PRAIRIE ISLAND NUCLEAR GENERATING PLANT
Docket No. 50-282 Licensing No. DPR-42
50-306 DPR-60

Supplemental Information - License Amendment Request
Dated January 31, 1980

Attachment to March 31, 1981 Letter
AUXILIARY SYSTEMS BRANCH (ASB)

FIGURE 1a
FOUR RACKS IMPACTING CENTRAL RACK

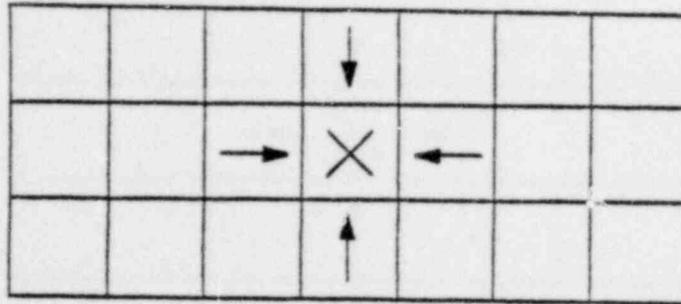
A. Effect of Four Adjacent Racks Impacting on the Central Rack

Simultaneous impact of four adjacent racks on the central rack, even though theoretically possible, would be an extremely rare event, since the to-and-fro sliding motions of the five racks are likely to be quite random in nature. The resulting potential damage to the racks from this postulated impact would be well within acceptable limits for the following reason: Evaluation results for a single rack impacting on the adjacent rack showed that, even if the computed impact velocity is increased by a factor of 2.7 (i.e., 12 over 4.43), the maximum crushing length of rack storage tubes due to impact is only 1.2 inches. This was computed by an energy balance method in which the kinetic energy of impact was equated to the strain energy of deformation of the impacting outer tube walls. This calculation was performed (as described in the response to SEB 9) by arbitrarily increasing sliding velocity from 4.43 inches/sec. to 12 inches/sec. and by ignoring the energy expended in tilting the racks. Since, in the case of a four-way impact, the outer tube walls of any particular side of the central rack would be impacted by only one sliding rack, the postulated damage to the impacted tube walls would remain the same.

FIGURE 1b
SIX RACKS IMPACTING END RACK

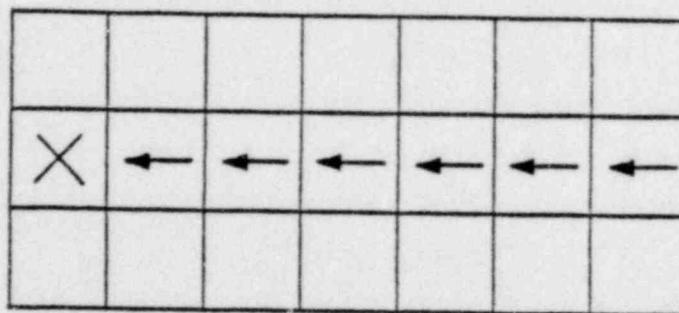
B. Effect of Six Racks in a Row Impacting on the Seventh Rack

The scenario is also very improbable because the to-and-fro sliding motions of the racks are random in nature and for the six racks to be moving in the same direction is very unlikely. Even more unlikely is the scenario in which all the six racks are moving at the peak velocity in the same direction. However, based on earlier single rack-to-rack impact analysis, this scenario is evaluated in a simple but conservative way to show the adequacy of the rack.

It is assumed that the combined kinetic energy of the six racks will be available as the energy of impact on the seventh or last rack. The total impact energy will then be six times 3759 in-lb (based on the computed peak sliding velocity of 4.43 inch/sec) or 22,554 in-lb.

As described in reference 3, the single rack-to-rack impact analysis was performed using an arbitrary sliding velocity of 12 in/sec instead of the computed value of 4.43 in/sec. This was done so as to show the existence of high margin of safety. The impact energy of a single rack at the 12 in/sec velocity is 26,733 in-lb. Thus, the rack was already evaluated for an impact kinetic energy of 26,733 in-lb, which is more than the 22,554 in-lb determined for six racks at the computed 4.43 in/sec velocity. Thus, even for the case when six racks in a row are postulated to impact on the seventh rack simultaneously, the damage to the rack storage tubes would not exceed 1.2 inches from the top. This was previously shown to be well within acceptable limits.

FIGURE 2
FUEL RACK CRUSHING LOCATION

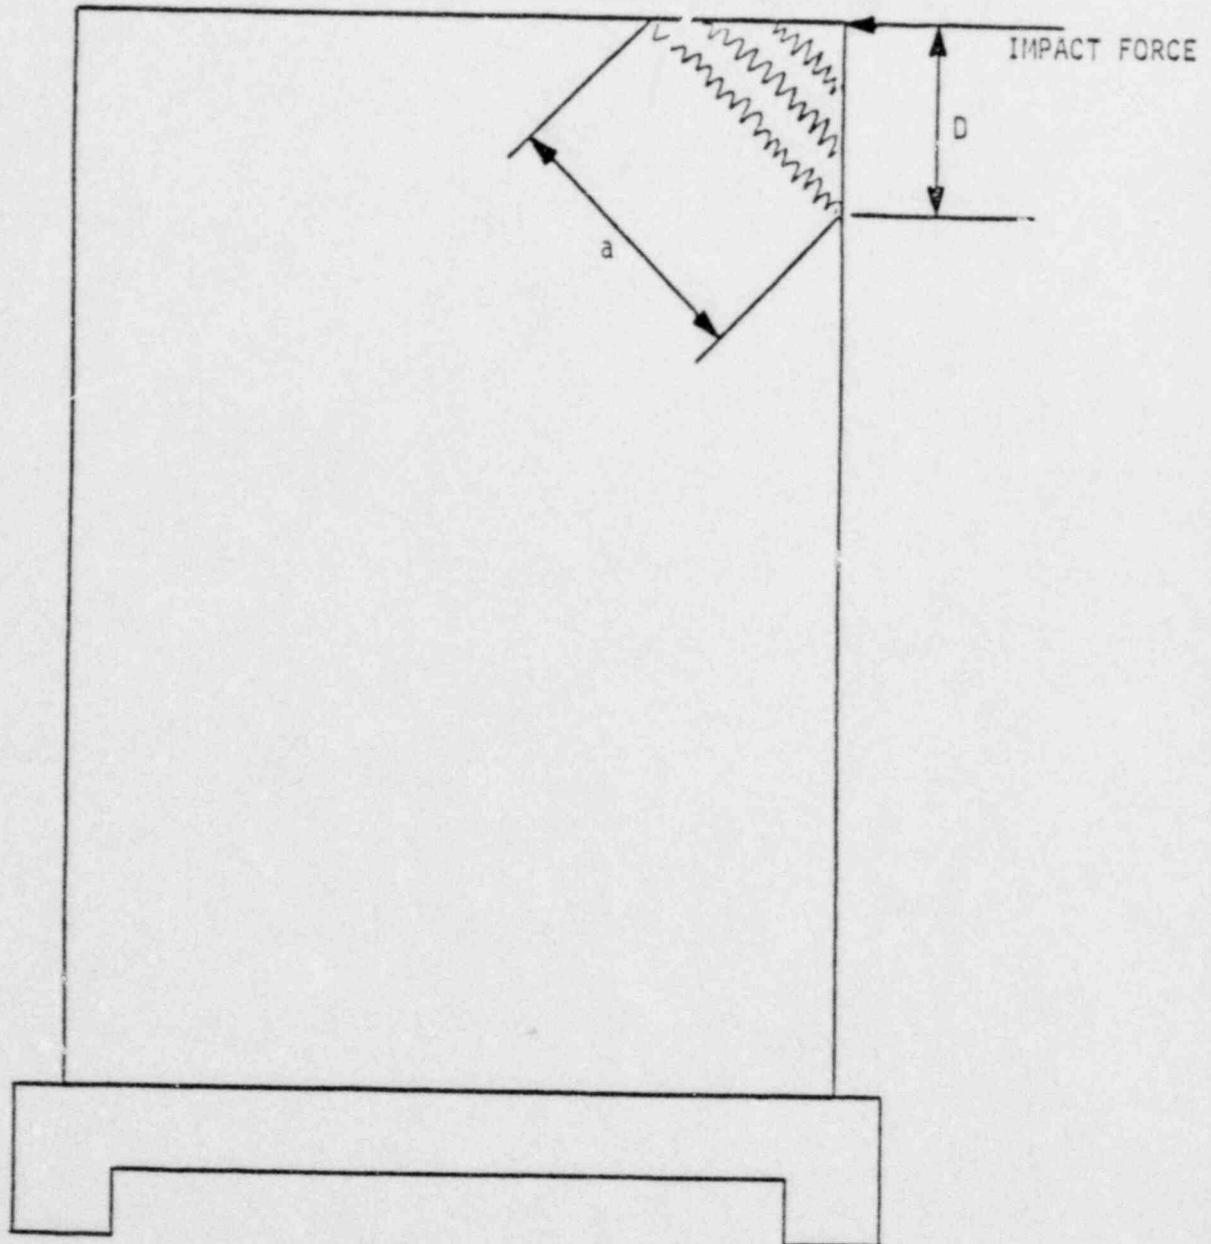
4. The top edge of the tube is assumed to get crushed. The extent of the crushing is defined as "a" in Figure 2. The value of "a" depends on the impact energy. Using an iterative method, the value of "a" is determined by equating the elasto-plastic strain energy of the crushed corner to the impact energy.

5. The vertical length of damaged rack "D" is computed from "a".
